National Park Service
Liberty Canyon Crossing EIR

Comments on Types and Specifications of Wildlife Crossings

Exhibit A

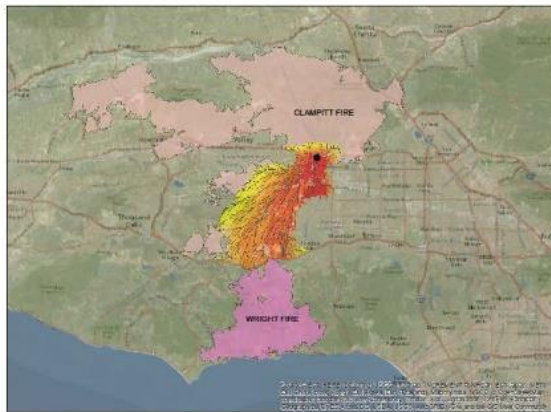
This particular fire corridor has been under attack many times in the past. The 143,740 acre giant Clampitt/Wright fire on August 25 1970 being the most noteworthy. (Exhibit A) Using USFS fire modeling techniques to demonstrate the current situation (exhibit B) it is not possible for surface fire to spread from the Simi Hills into the Santa Monica Mountains, offering a significant level of protection from fire crossing the 101 freeway. The proposed wildlife crossing will radically alter the status quo, (Exhibit C)
